Appendix A
Site Inspection Report

RE: NRCS Inspection of Mott Dam - 2020

On November 5th, 2020, NRCS engineering staff performed a dam inspection of Mott Watershed Dam (here after referred to as Mott Dam) in Mott, ND.

MOTT DAM - STRUCTURE SKETCH

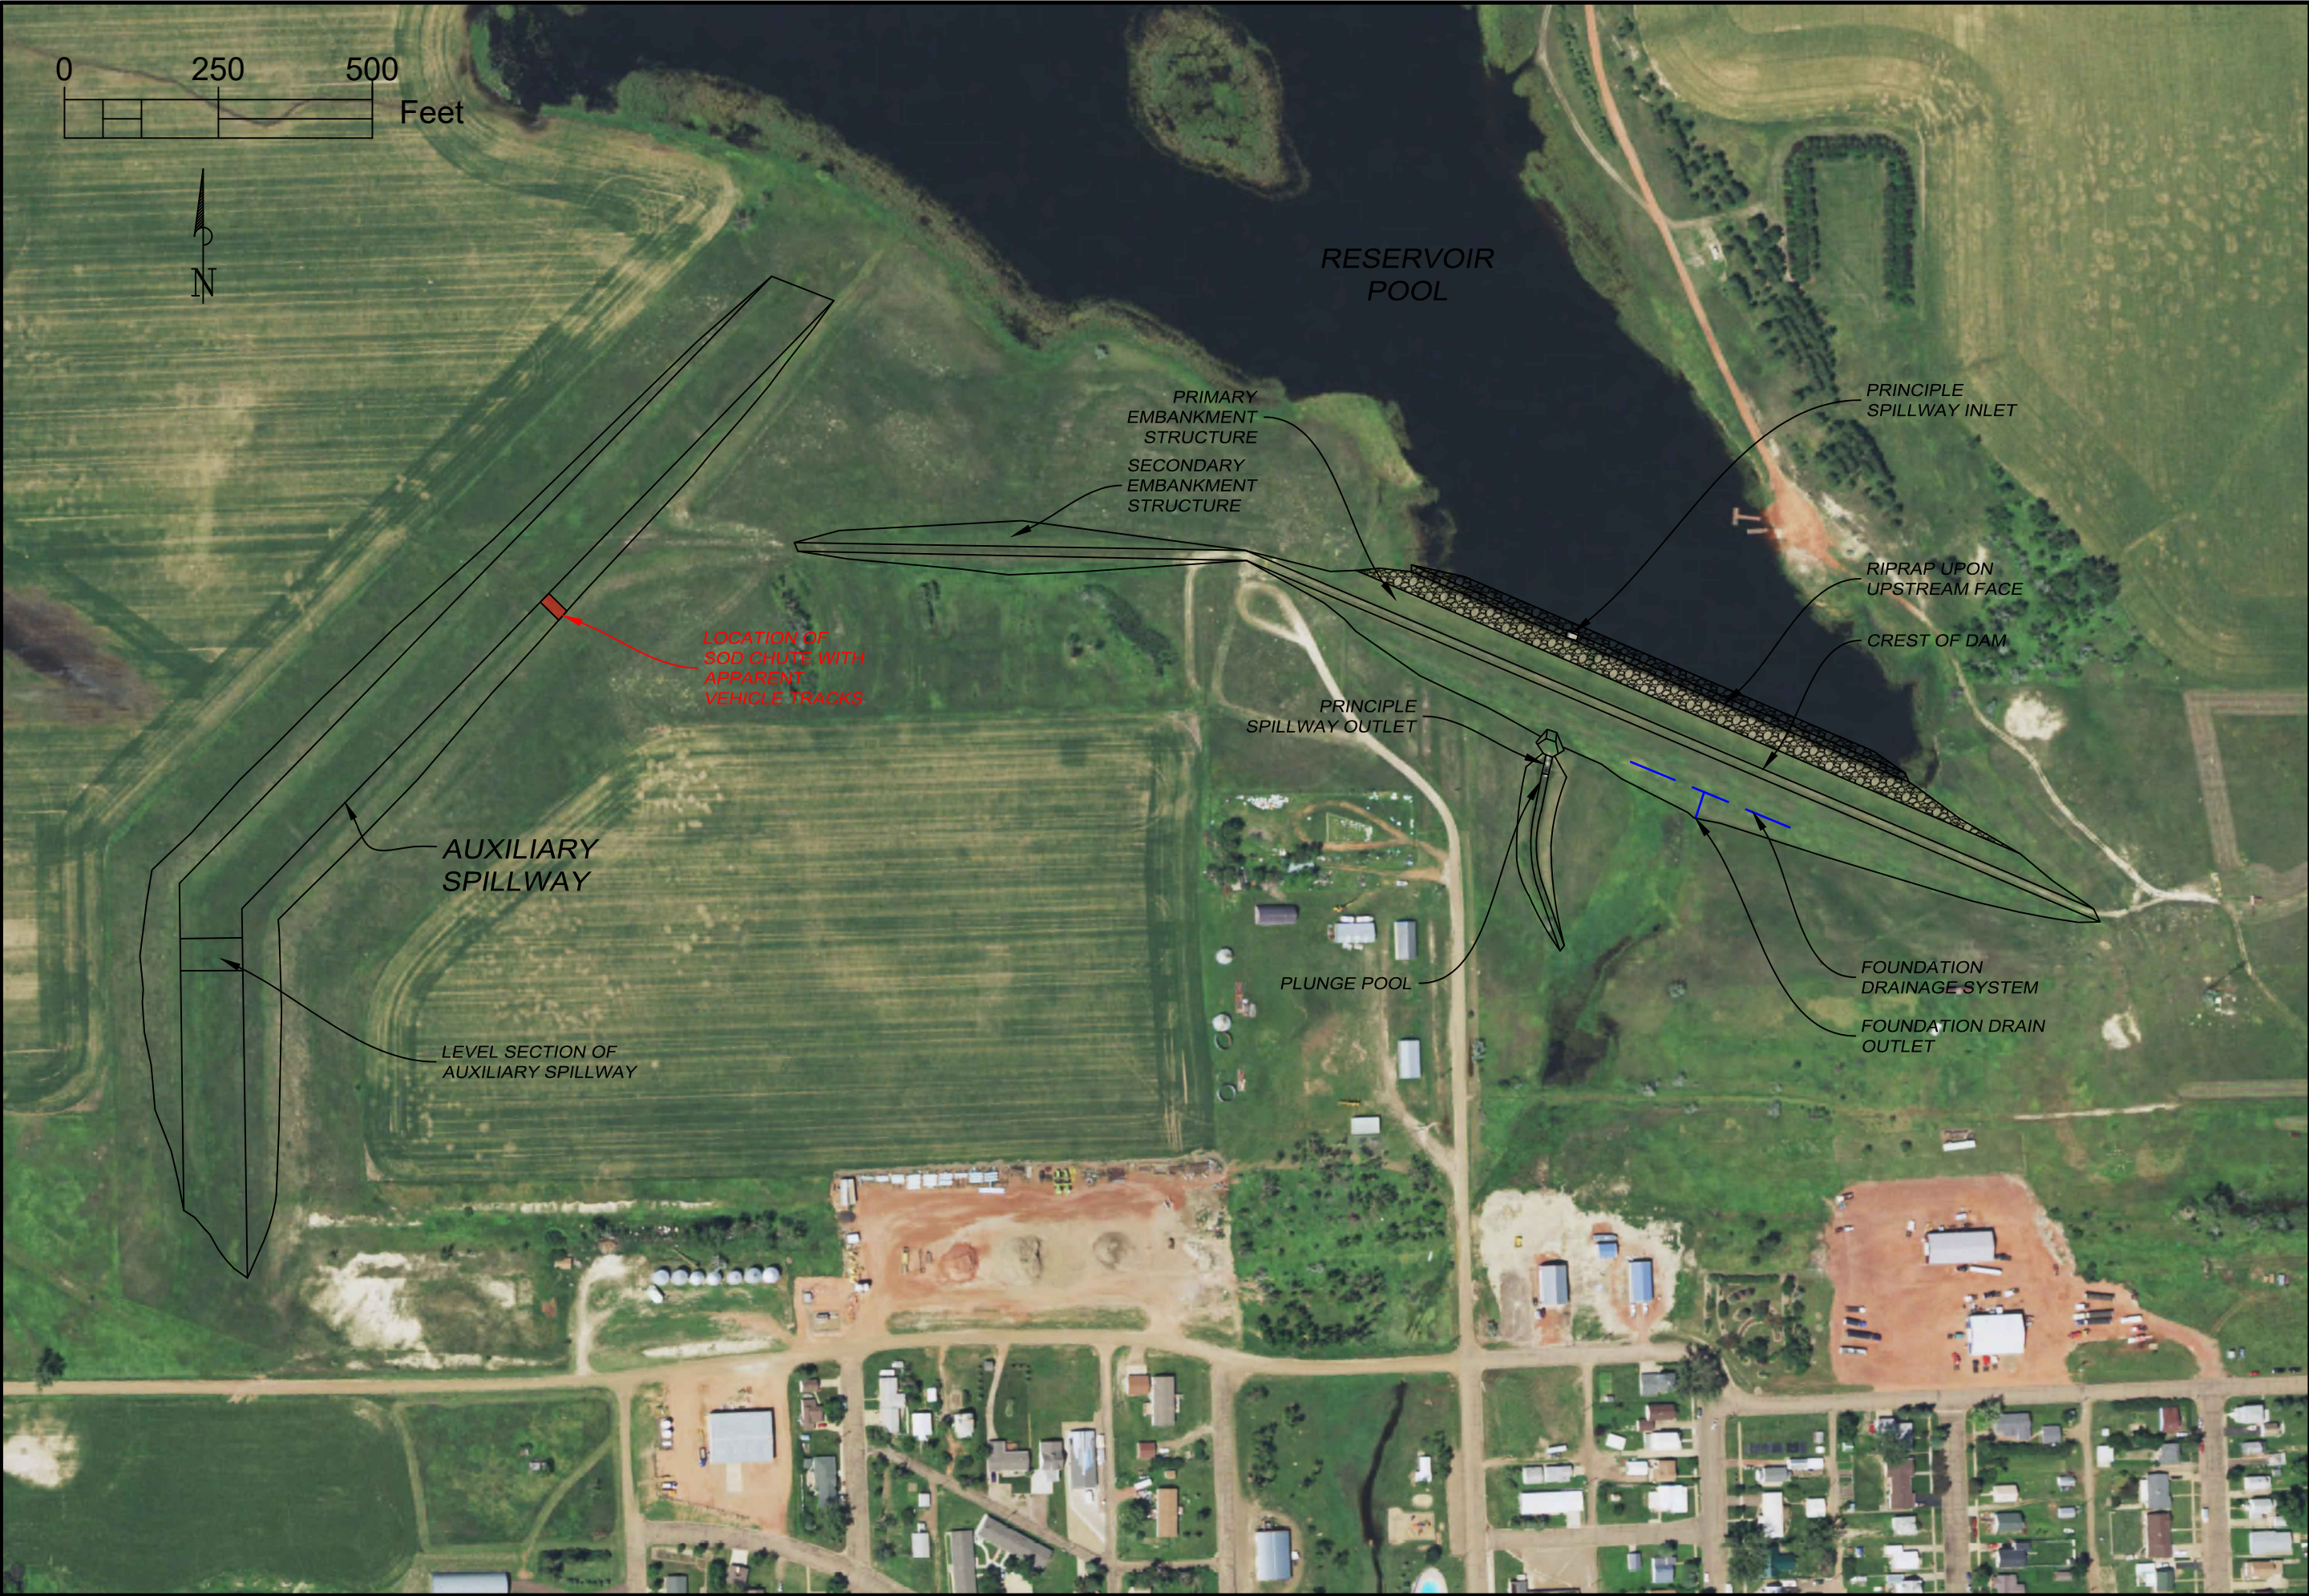
The compacted earth-fill embankment dam is 2,218 feet long and has a height of 39 feet. The dam is a homogeneous embankment and has a 16'-0" crest width with a 2 ½:1 downstream embankment slope and a 3 ½:1 upstream embankment slope. The embankment has a primary embankment located at the principle spillway works and one secondary (smaller) embankment which bends and extends toward the auxiliary spillway. See Structure Sketch.

Photo #17 - View of looking down Principle Spillway Conduit from within Riser Tower Structure

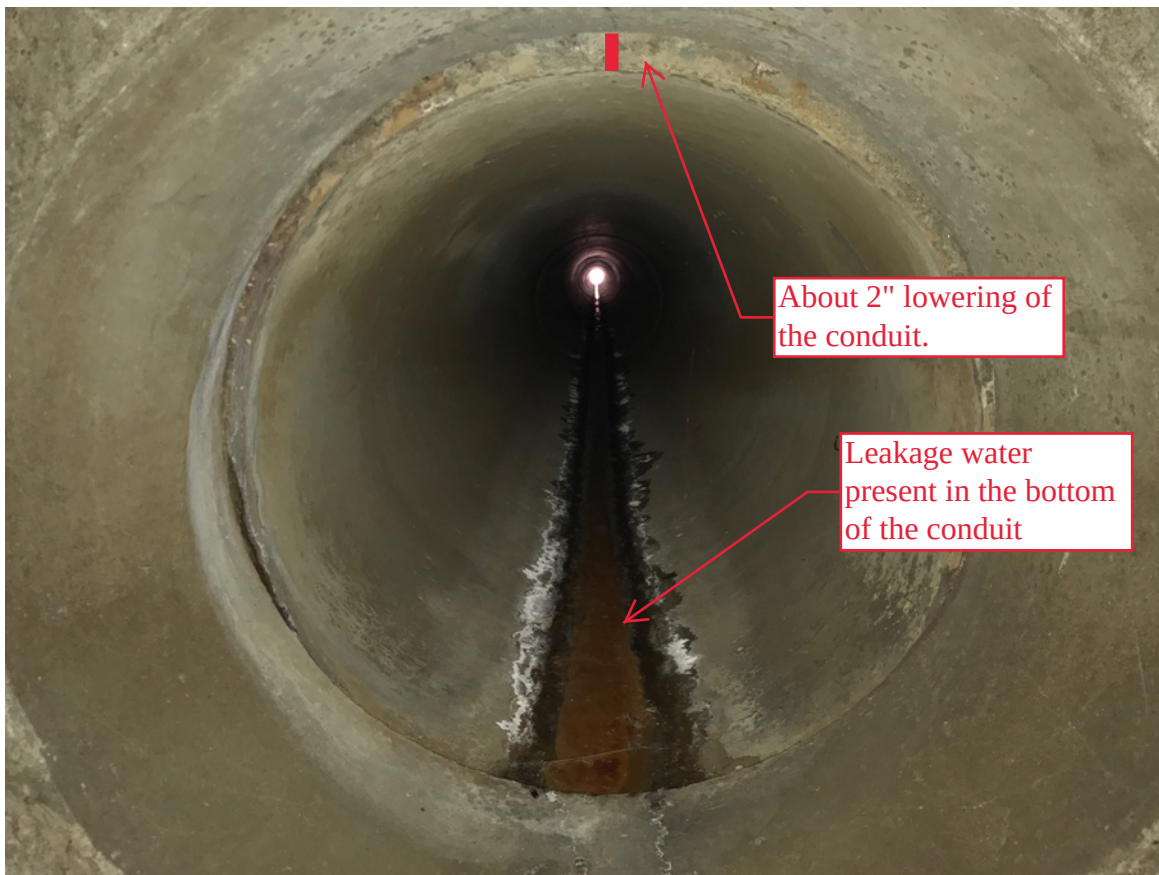
The principle spillway conduit was viewed from within the riser tower structure and at the outlet end. (See picture 17 and 33). As stated before, the stage-1 inlet was not flowing and there was no water present in the bottom of the riser tower inlet structure. As seen in picture 17 there was found a leak occurring at the joint of the conduit to the riser tower structure. On November 17th the interior of the conduit was inspected by an inspection rover with mounted camera. Each joint of the conduit was inspected as well as the walls of the conduit, starting from the outlet end and extending the entire length of the conduit and into the riser tower structure. All the joints were in good condition having no significant gaps or apparent loss of joint material. No additional leakage was found through conduit joints, besides the leakage from the conduit joint to the riser tower structure. As there was water in the bottom of the conduit, additional leakage at the bottom of the conduit, at joints, could not be assessed. The amount of water in the bottom of the conduit was uniform over the entire length of the conduit and no large increases at intermediate joints were witnessed, concluding that the source of the leakage is entirely from the conduit joint at the riser tower structure. This joint has lowered about 2" from the original location, which originally the conduit walls line up flush with the round opening to the riser tower structure.

There is no cracking of the conduit or of the riser tower structure at the location of the conduit joint to the riser tower structure. This misalignment distance between the conduit and the opening into the riser tower structure should be monitored for further movement. The leakage at the conduit joint should be repaired by sealing the joint so that no further leakage occurs. This repair should be monitored over time to ensure no damage occurs from unexpected future movement of either the riser tower structure or the conduit. It is inconclusive as to the cause of

Photo #19 - View of Stage-1 Inlet Trash Rack

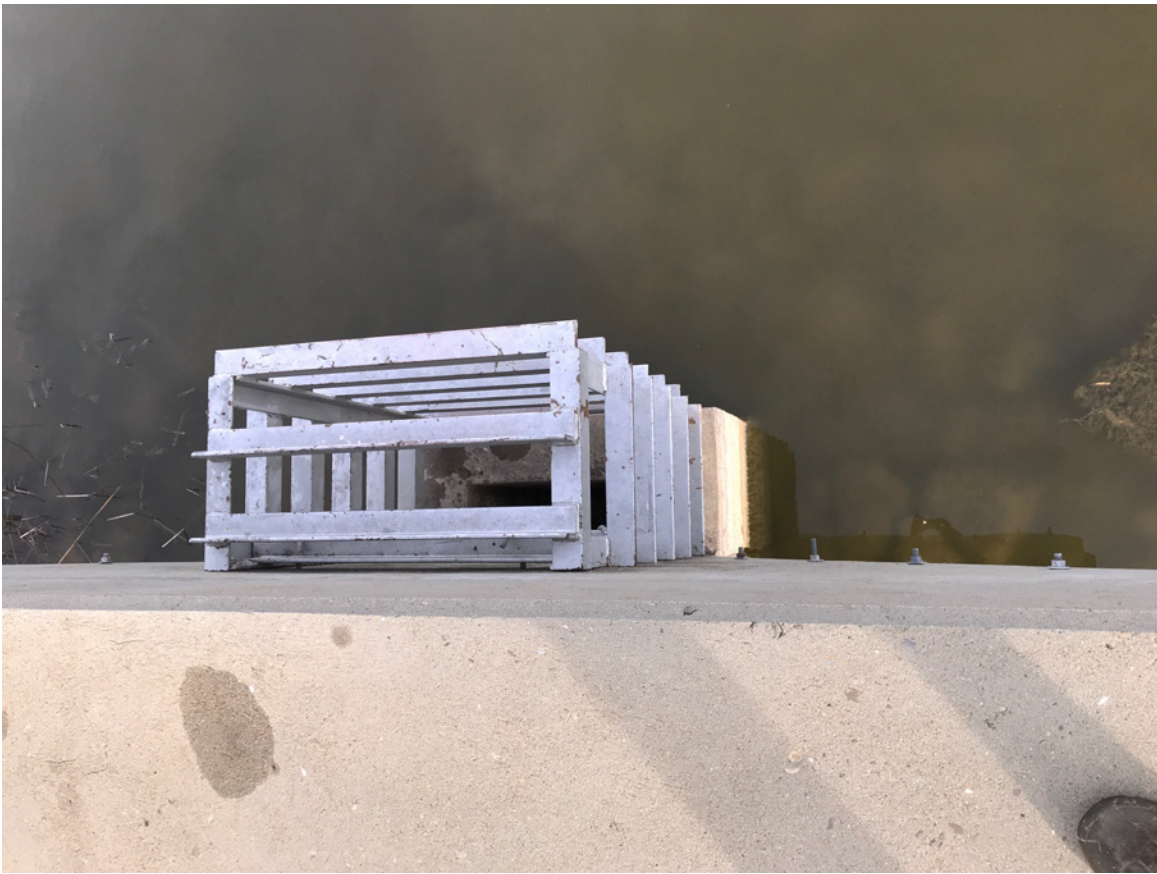
The trash rack steel elements and connections to the concrete for the stage-1 and stage-2 inlets are intact and have sufficient structural integrity (See pictures 19, 24, 25 and 26). The steel has been retrofitted with galvanized protective paint and is in good condition.
